July 12, 2013

In Section 2.6 of the Final Environmental Impact Statement (FEIS) for the proposed SunZia transmission project, the BLM presented three alternatives for the amendment of Resource Management Plans (RMPs) that would be affected by the proposed action of the applicant (SunZia Transmission LLC). These three alternatives were the No Action Alternative, a 400-foot corridor, and a 2500-foot corridor. The BLM's preferred alternative is the 400-foot-wide corridor that may be included as an amendment to RMPs for conformance with visual resource management and right-of-way management objectives. Under the full range of route alternatives, the following RMPs in New Mexico and Arizona would be subject to amendment:

Concise statement of why the BLM's preferred RMP amendment alternative is the wrong choice:

As coordinator of The Friends of the Aravaipa Region (FAR), I protest this Resource Management Plan (RMP) amendment alternative, and request that the No Action RMP amendment alternative be taken instead. The Bureau of Land Management (BLM) has a mandate under the National Environmental Policy Act (NEPA) to analyze the effects of the proposed action by the applicant. There are

Figure 12: HPX Benefit/Cost Analyses Results

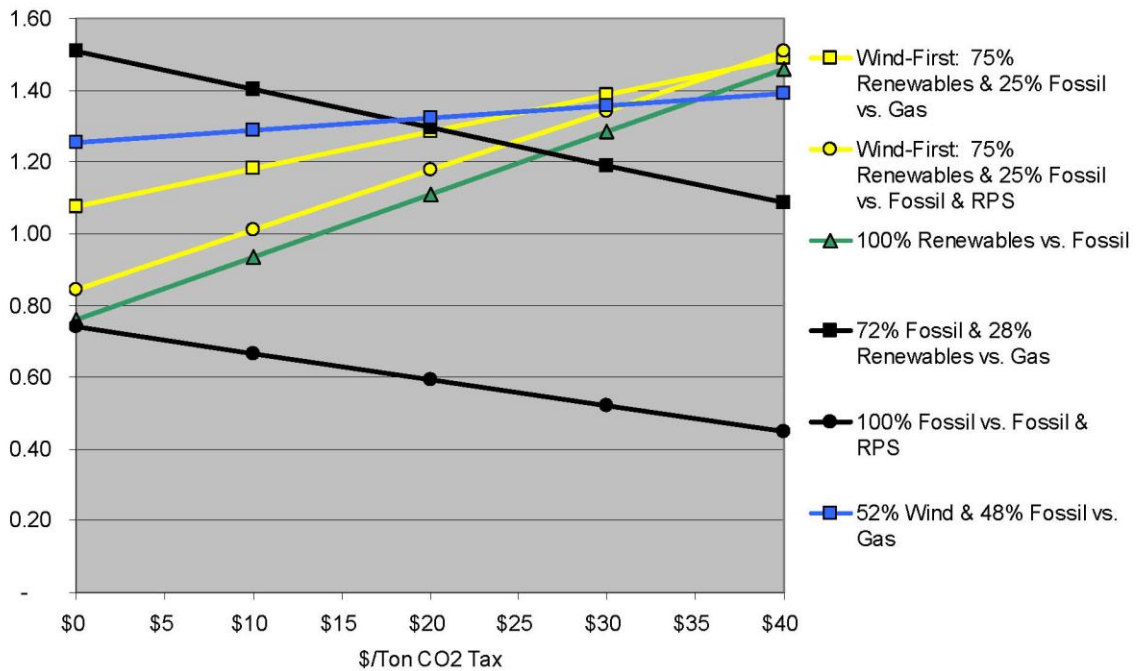
According to the HPX analysis, the energy development forecast presented in the FEIS ("wind first" scenario vs. existing mix of fossil fueled generation and minimum renewables to meet RPS) will not break even economically (B/C=1) on an Extra High Voltage (EHV) line unless CO2 emissions are taxed at \$10 per ton, and does not perform as well as the more balanced energy scenarios until CO2 emissions are taxed at \$25 per ton. Further, the energy mix that has, by far, the highest B/C ratio and the highest economic advantage to investors and consumers under current market conditions is actually the **inverse** of the energy development forecast presented in the FEIS, one that consists of 75% fossil fueled generation and 25% renewable generation. In Attachment B, note that Table 8 assumes a minimum CO2 emissions tax of \$10/ton. However, the Figure 12 graph does model the absence of a CO2 emissions tax.

These *operational and economic challenges* are reflected in the prohibitively low economic feasibility ratings for the *renewable-dominated* scenarios in the absence of a CO2 emissions tax. Note that the HPX study considered 75% renewables to be the high limit for the *renewable-dominated* category. SunZia's 94% renewable scenario is considered to be a *renewables-only* scenario, which provides less than 60% EHV line utilization (Attachment B).
